Wisconsin Department of Transportation

Proposal #26: 1196-00-70, WISC 2018 099
Minong – Solon Springs
Bus 53 (Minong) to CTH T (Nb)
USH 53
Washburn & Douglas County

This is Addendum No. 01, which provides for the following:

ADDENDUM NO. 01

Addendum No. 01
 ID 1196-00-70
 Revised Sheet 6
 February 8, 2018

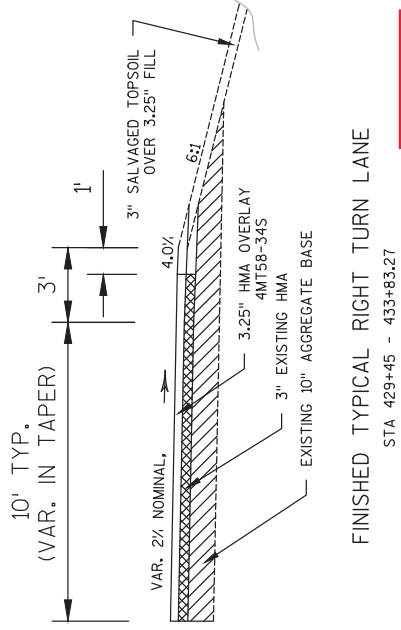
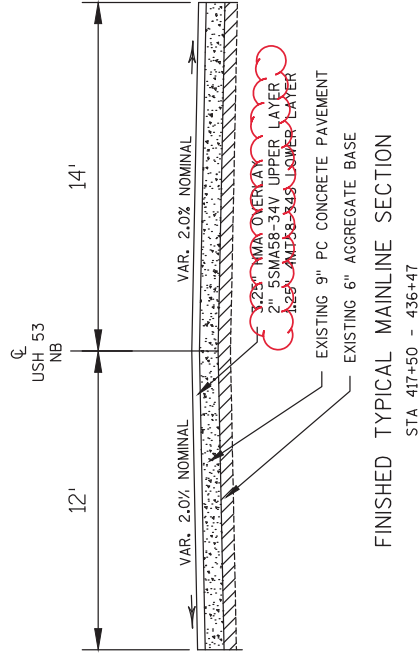
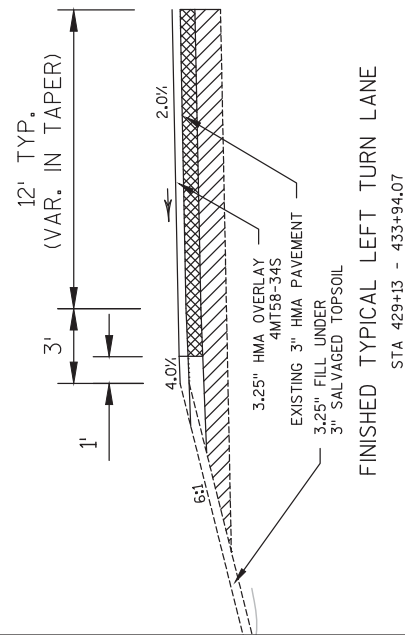
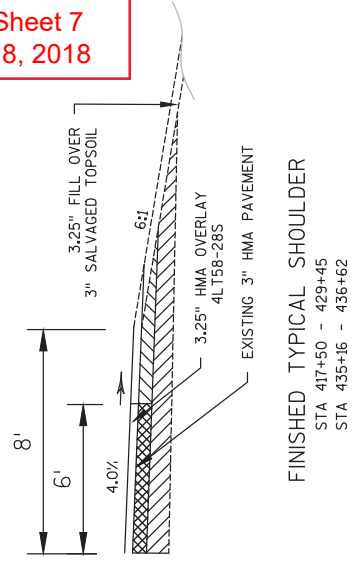
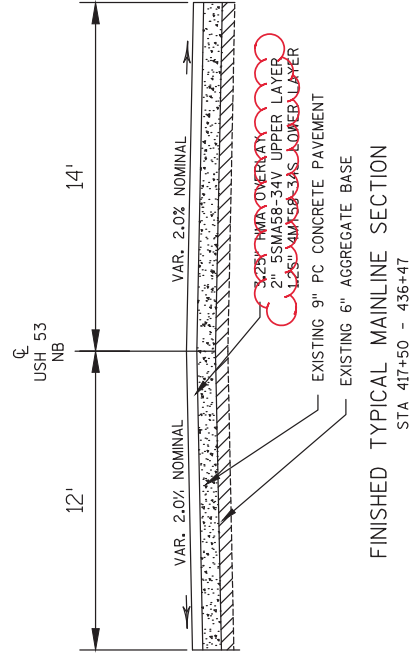
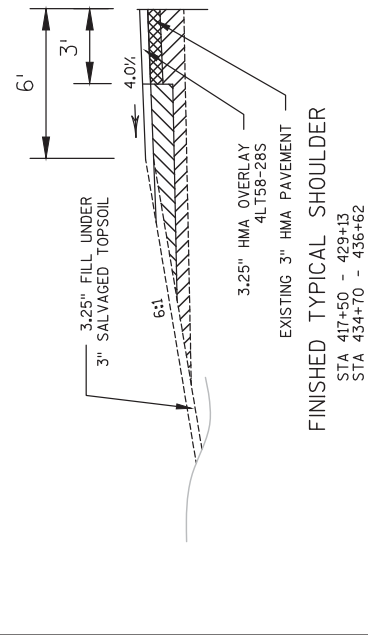
Revised Plan Sheets	
Plan Sheet	Plan Sheet Title (brief description of changes to sheet)
6,7	Finished Typical Sections (changing labels to reflect asphalt mix changes)
21,22	Misc. Quantities (changes to reflect changes in applicable quantities and bid items)
